CITY PLAN COMMISSION**THURSDAY, DECEMBER 5, 2024****FILE NUMBER:** S245-043**SENIOR PLANNER:** Sharmila Shrestha**LOCATION:** Grady Niblo Road at Merrifield Road, northwest corner**DATE FILED:** November 7, 2024**ZONING:** PD 655**PD LINK:** <https://dallascityhall.com/departments/city-attorney/Articles/PDF/Article%20655.pdf>**CITY COUNCIL DISTRICT:****SIZE OF REQUEST:** 61.5-acres**APPLICANT/OWNER:** Potters House of Dallas, Inc.

REQUEST: An application to create 324 residential lots with lots ranging in size from 3,210 square feet to 7,934 square feet and 9 common areas from a 61.5-acre tract of land in City Block 8710 on property located on Grady Niblo Road at Merrifield Road, northwest corner.

PRELIMINARY PLAT
CAPPELLA PARK SOUTH
JOHNSON VOLK CONSULTING INC.
10000 W. CENTRAL EXPRESSWAY, SUITE 100
DALLAS, TEXAS 75243

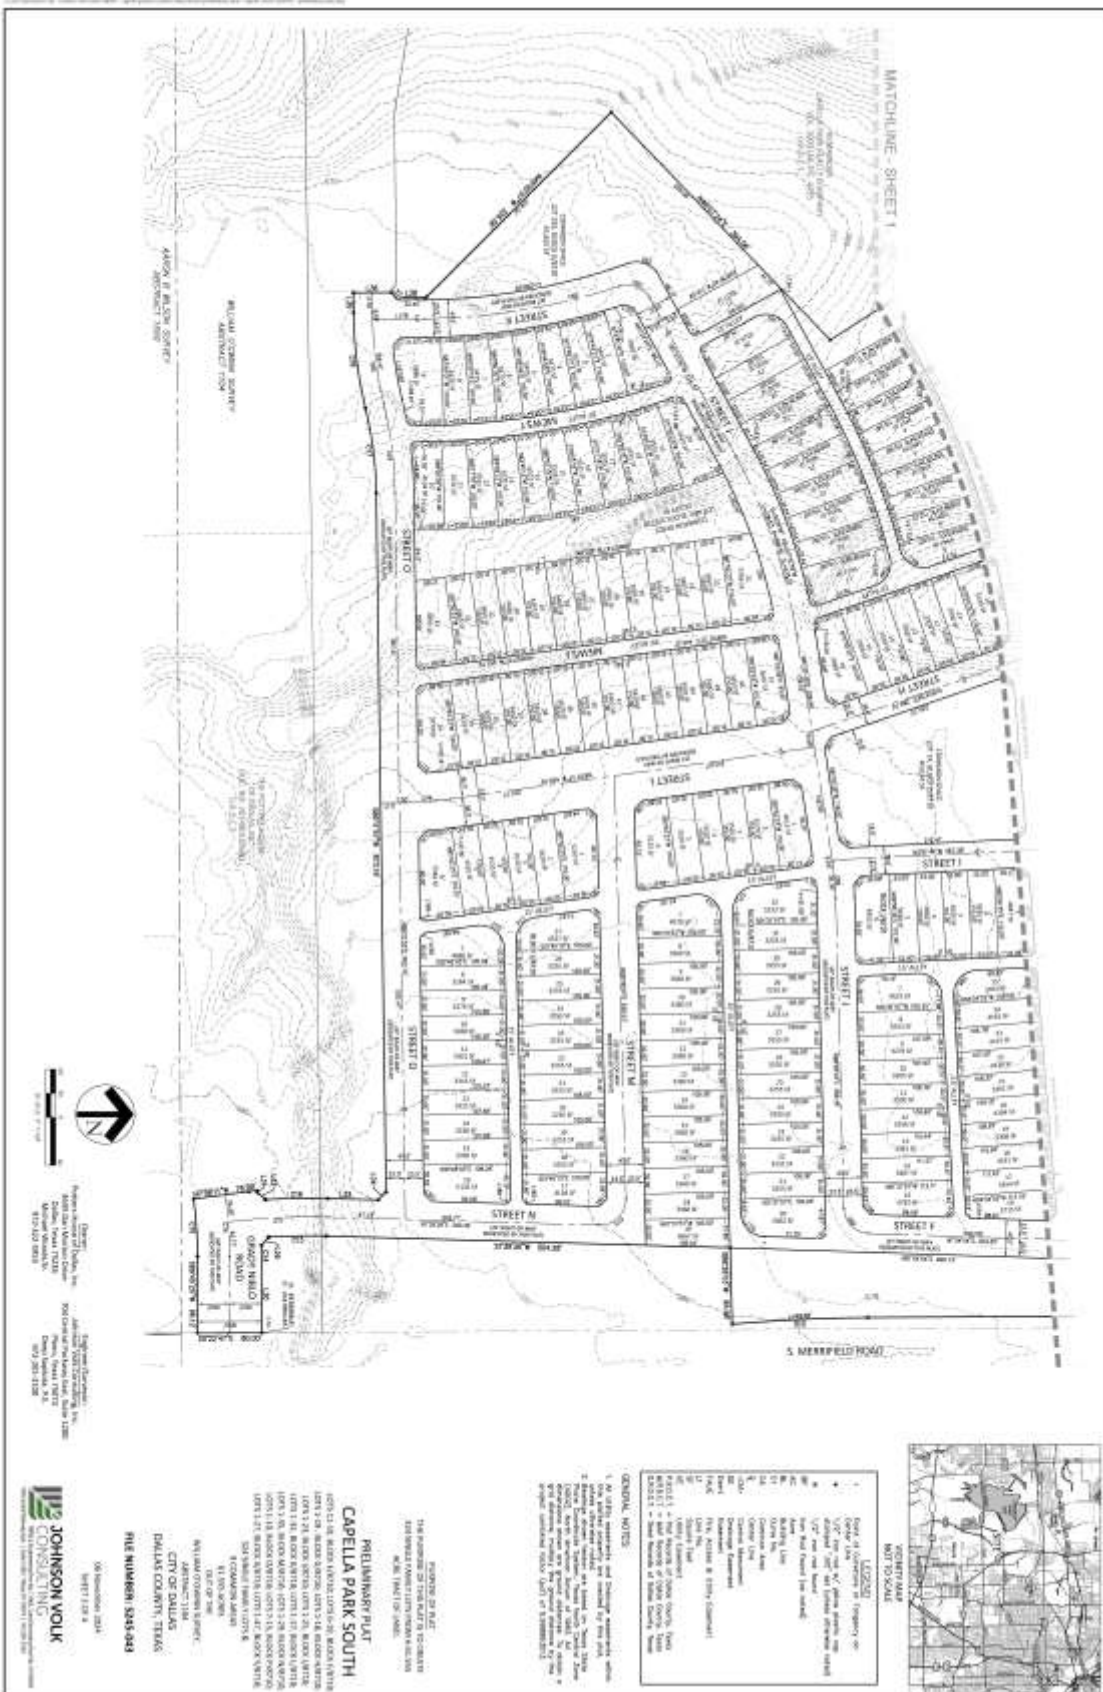
15. On the final plat, dedicate 53.5 feet of right-of-way (via fee simple or street easement) from the established centerline of South Merrifield Road. *Sections 51A-8.602(c), 51A-8.604(c) and 51A-8.611(c).*
16. On the final plat, dedicate 53.5 feet of right-of-way (via fee simple or street easement) from the established centerline of Grady Niblo Road. Sections 51A-8.602(c), 51A-8.604(c) and 51A-8.611(c).
17. On the final plat, dedicate 7.5 feet of right-of-way (via fee simple or street easement) from the established centerline of alley. Sections 51A-8.602(c), 51A-8.604(c) and 51A-8.611(c).

18. On the final plat, dedicate 25 feet of right-of-way (via fee simple or street easement) from the established centerline of Covenant Road. Sections 51A-8.602(c), 51A-8.604(c) and 51A-8.611(c).

19. On the final plat, dedicate 25 feet of right-of-way (via fee simple or street easement) from the established centerline of Samaritan Road. Sections 51A-8.602(c), 51A-8.604(c) and 51A-8.611(c).

20. On the final plat, dedicate 25 feet of right-of-way (via fee simple or street easement) from the established centerline of all internal street. Sections 51A-8.602(c), 51A-8.604(c) and 51A-8.611(c).

21. On the final plat, dedicate a minimum 5-foot by 5-foot corner clip (via fee simple or street easement) at the intersection of all street corner. Section 51A 8.602(d)(1)

23. On the final plat, dedicate a 15-foot by 15-foot Alley Sight Easement at all intersection & the alley. Section 51A-8.602(e)
24. Construct one-half of the Merrifield Road thoroughfare requirements along the entire length of the proposed plat per the City of Dallas standard. 51A 8.604(b)(3)

26. Prior to final plat, submit a completed final plat checklist and all supporting documents.
27. On the final plat, show how all adjoining right-of-way was created. Section 51A-8.403(a)(1)(A)(xxii).
28. On the final plat, show distances/width across all adjoining right-of-way. Platting Guidelines.
29. On the final plat, show recording information on all existing easements within 150 feet of the property.
30. On the final plat, remove building line(s). Platting Guidelines.

34. Prior to final plat, comply with City's Street lighting standards including illumination standards, material, installation, and activation per Street Design Manual.
35. On the final plat, change "S. Merrifield Road" to "Merrifield Road". Section 51A-8.403(a)(1)(A)(xii).
36. On the final plat, change "Patience Blvd." to "Patience Boulevard". Section 51A-8.403(a)(1)(A)(xii).
37. Prior to final plat, contact the Street Name Coordinator to obtain an approved street name". Sections 51A-8.403(a)(1)(A)(xii).
38. On the final plat, identify the property City Block E, H, J, N, P, AA, DD/8710.
